UNITED STATES PATENT AND TRADEMARK OFFICE

| APPLICATION NO. | FILING DATE | FIRST NAMED INVENTOR | ATTORNEY DOCKET NO. | CONFIRMATION NO. |
|---|-------------|----------------------|---------------------------------|-----------------------------|
| 09/856,175 | 06/04/2001 | Hiromu Ueshima | 100341-00008 | 9628 |

Office Action Summary

DETAILED ACTION

(Fig. 1 has been modified below to more clearly illustrate the relationship between the switch and the grip).

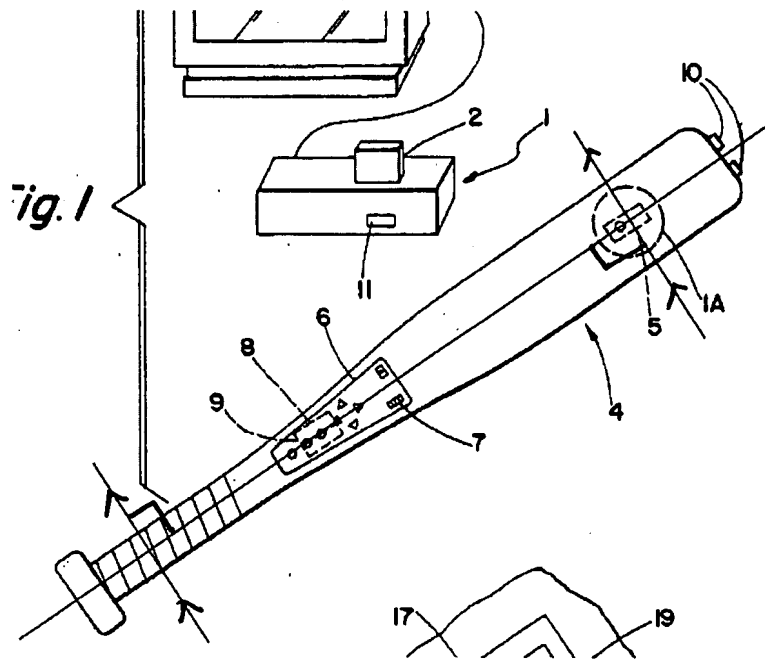
Lipps et al. teaches that the batter's swing is sensed via a centrifugal switch and the appropriate signals are transmitted to a game system. When the bat is swung, the centrifugal force (acceleration correlated signal) causes a weight to move toward a switch. At swing speeds faster than some critical speed, the weight has enough force to actuate the switch (col. 5, lines 58-67; col. 6, lines 12-26). It is noted that the main surface of said switch is considered to be both parallel and perpendicular to said grip
